Product Change Notification

Date Issued :	August 11, 2023	PCN Number :	514140
Reason for Change :	Change to Product		
Description of Change :	Molex is introducing a slight geometry change (relief slot) to the MX150 product family to eliminate the need for moisture conditioning the connector housing prior to the finished goods assembly process.		
Assessment of Change :	Dimension analysis		
Planned Implementation Date :	February 20, 2024		
Sample Availability Date:	January 16, 2024		
Internal Molex Qualification Date :	February 05, 2024		
Last date to request Samples by Customer :	December 01, 2023		
Traceability Code Markings / Date :	No special marking on the product or packaging

Change Overview

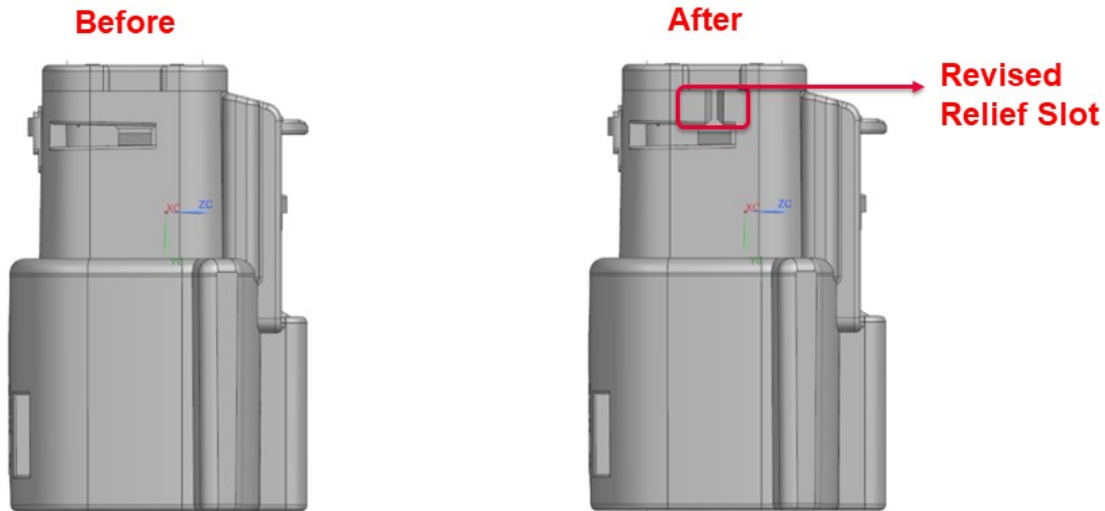
- Molex is introducing a slight geometry change (relief slot) to the MX150 product family to eliminate the need for moisture conditioning the connector housing prior to the finished goods assembly process. Refer to existing and revised housing geometry shown.

- The existing connector housing design requires moisture conditioning to avoid damage during the assembly process. The revised design is a permanent change that eliminates the potential damage and the need for moisture conditioning.

- There is no impact to part fit or function. There is a visual difference between the existing and revised connector housing where plastic has been removed for the relief slot.
